MIL-F-63232A (AR)
AMENDMENT 2
12 JULY 1989

MILITARY SPECIFICATION

FUZE, PIBD, M740, FUZE MODULE FOR

FIGURE 2

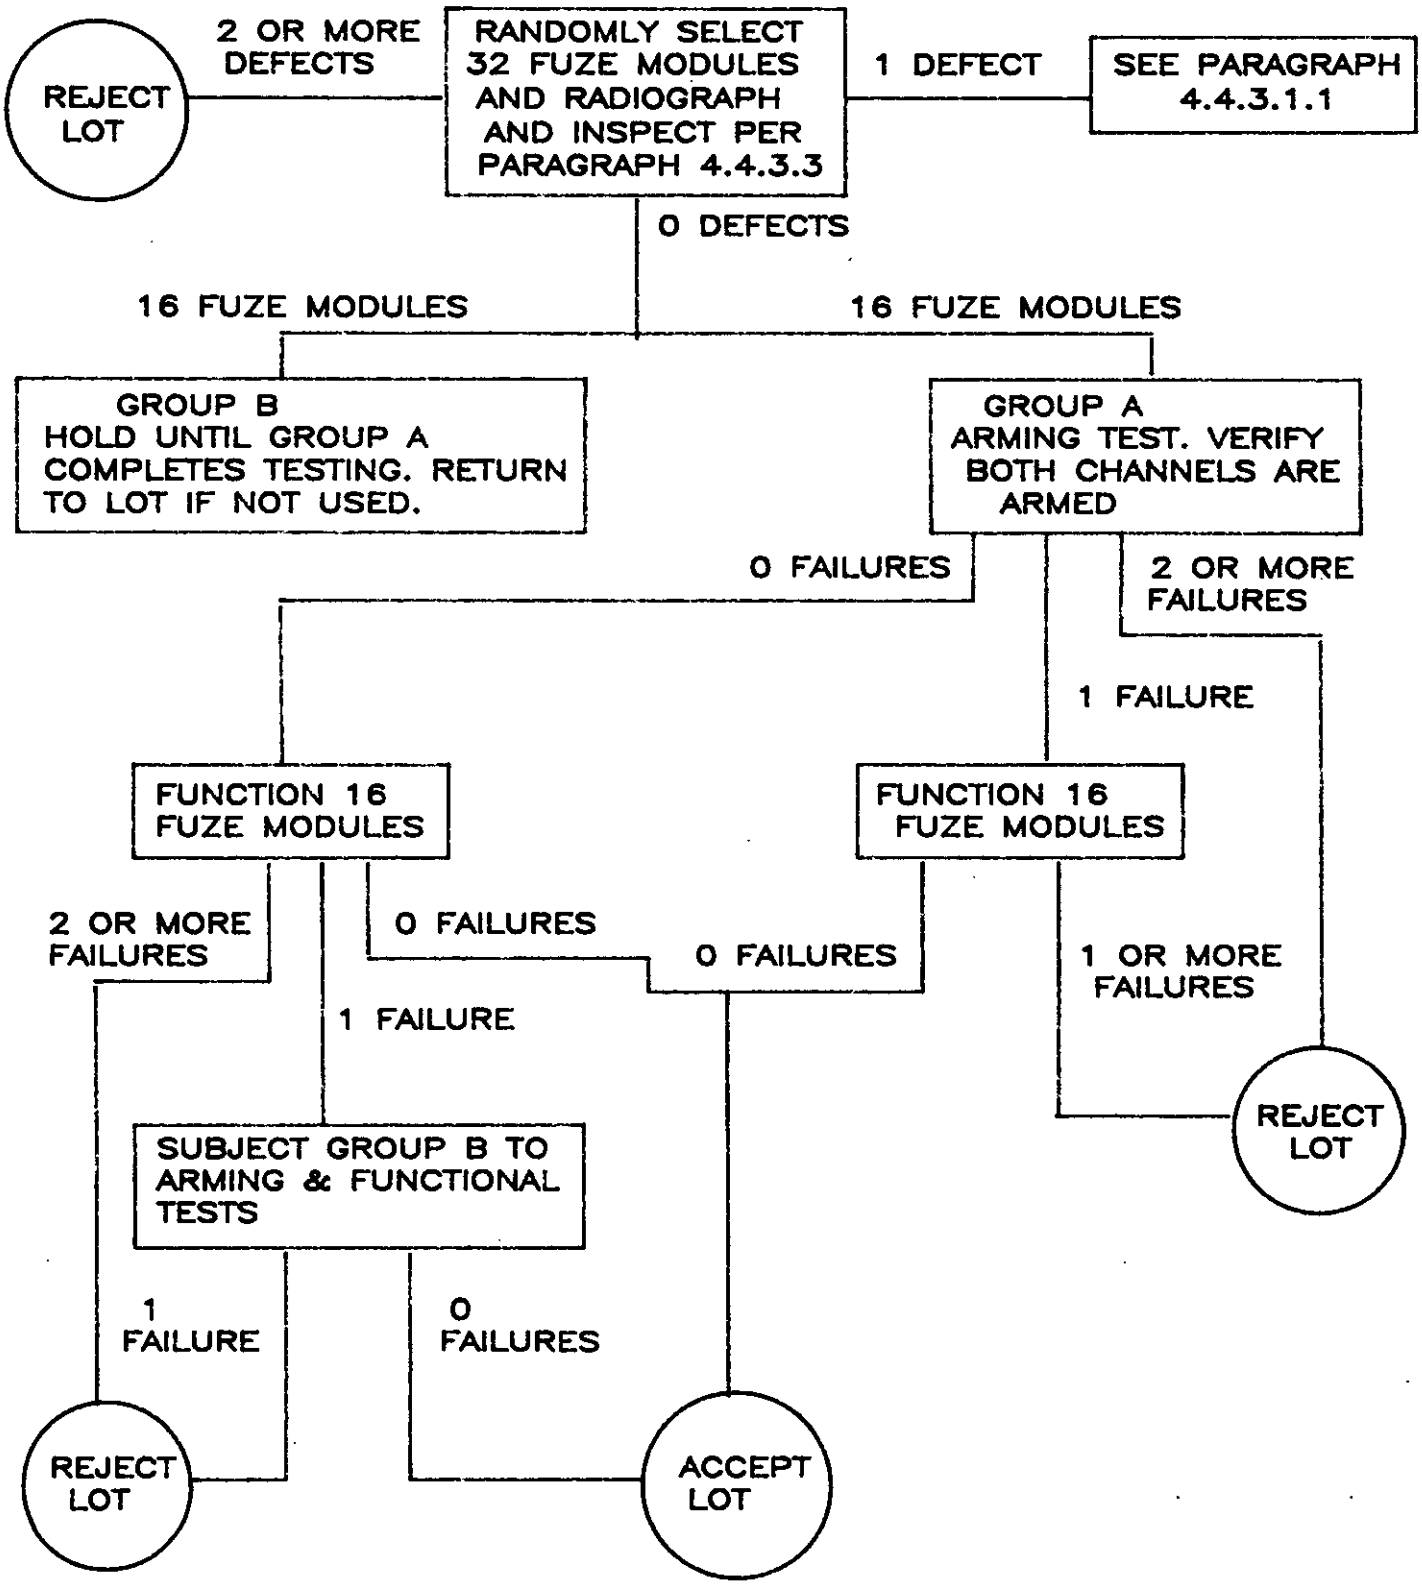
* Delete 4.4.3.1. in it's entirety and add the following:

"4.4.3.1 Initial sampling procedure for fize module assembly. Beginning with the first lot produced and continuing until three (3) consecutive lots have been found acceptable, a sample of thirty-two (32) fuze modules assemblies shall be randomly selected from each lot and radiographed. Each radiograph shall be inspected for defects as described in paragraph 4.4.3.3. If two (2) or more defects are found, then the lot shall be rejected. If one (1) defect is found, then proceed with testing as described in paragraph 4.4.3.1.1. If no defects are found, then the sample is to be divided into two (2) groups, A and B, each consisting of sixteen (16) fuze modules. Testing shall continue as shown in Figure 2."

* Add Figure 2 and Figure 3

FIGURE 3

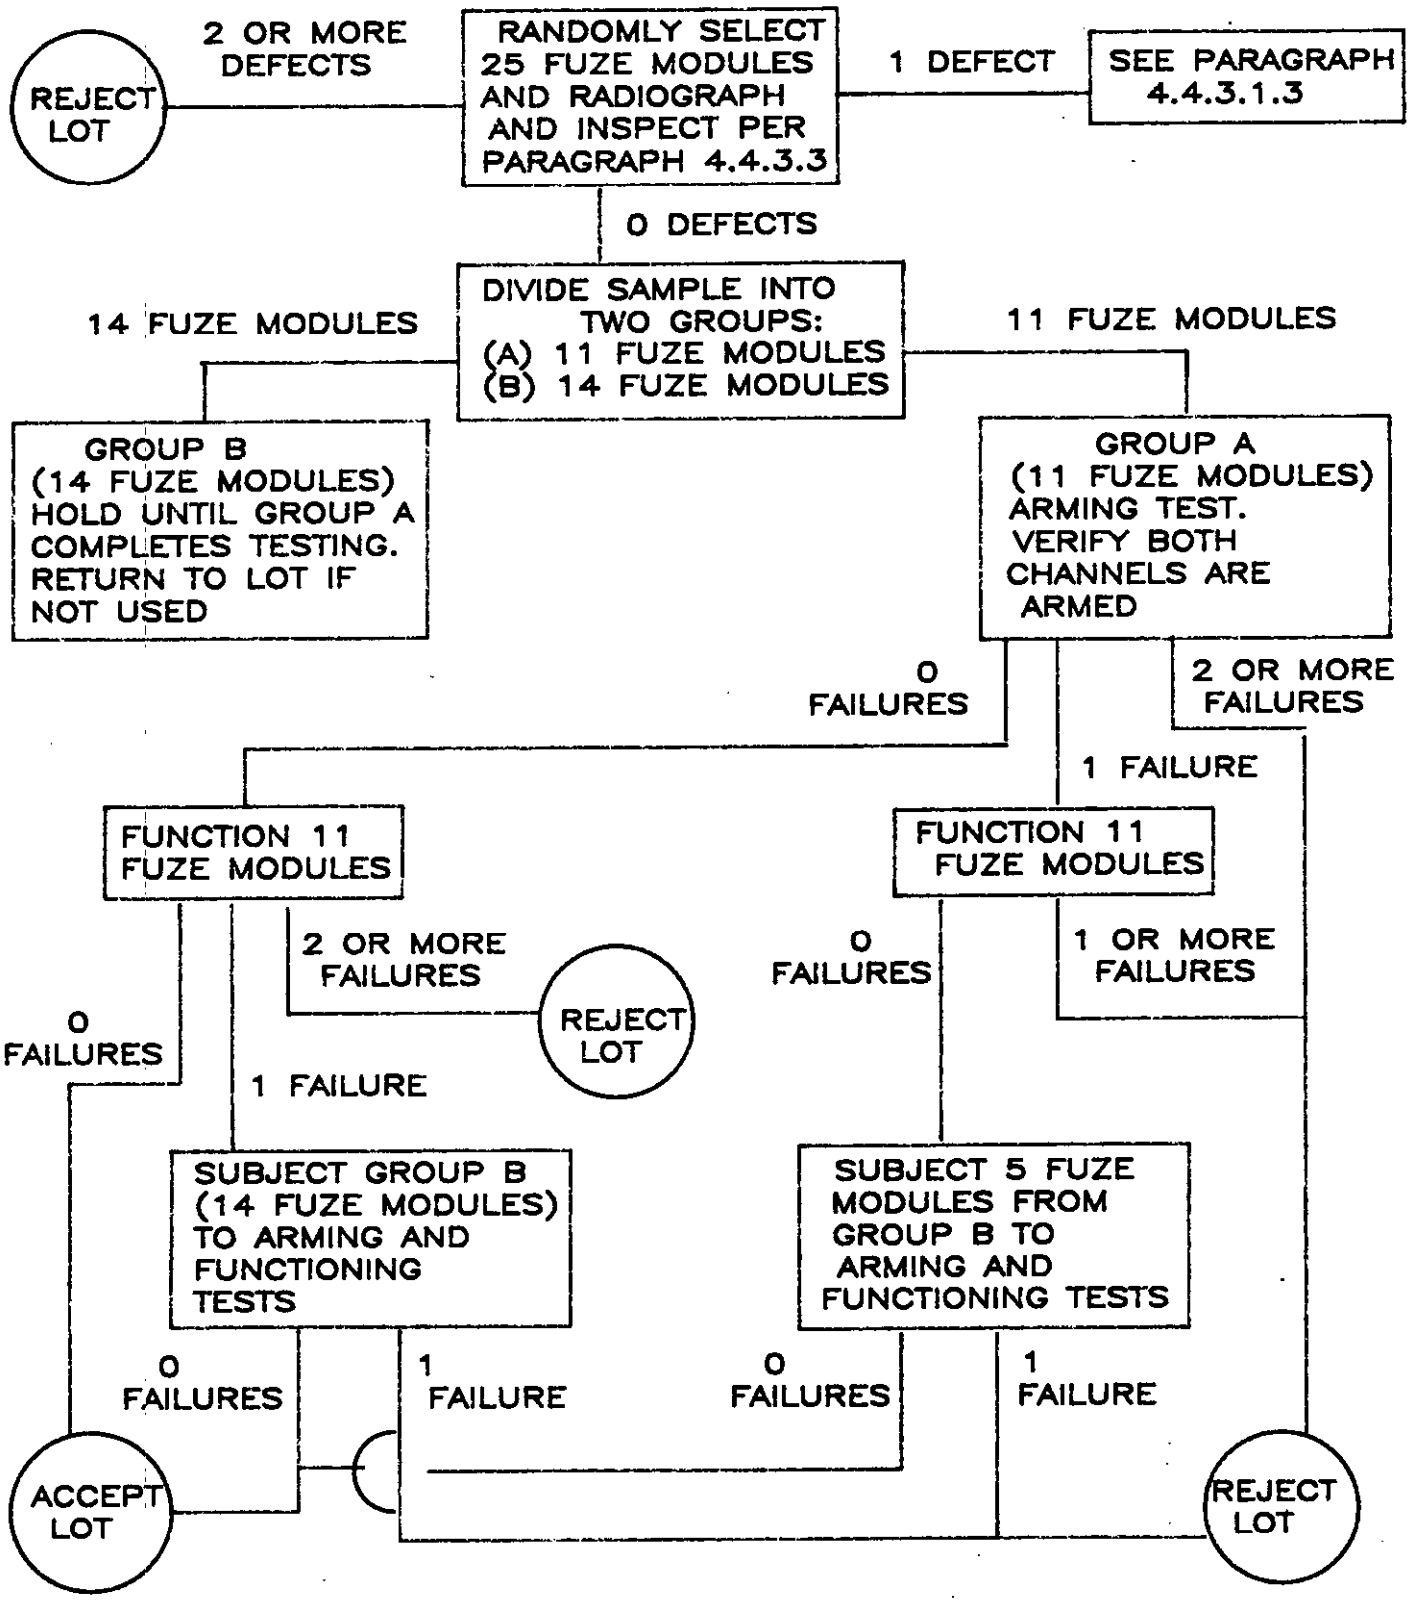
* Add the following paragraphs:

"4.4.3.1.2 Subsequent sampling procedure for fuze module assembly. After three (3) lots have complied with the criteria of 4.4.3.1, the sample size shall be twenty-five (25) fuze module assemblies. The entire sample shall be radiographed and inspected for defects as described in 4.4.3.3. If two (2) or more defects are found, then the lot shall be rejected. If one (1) defect is found, then proceed with testing as described in 4.4.3.1.3. If no defects are found, then the sample is to be divided into two (2) groups, A & B. Group A shall consist of eleven (11) fuze modules and Group B will consist of the remaining fourteen (14) fuze modules. Testing shall continue as shown in Figure 3.
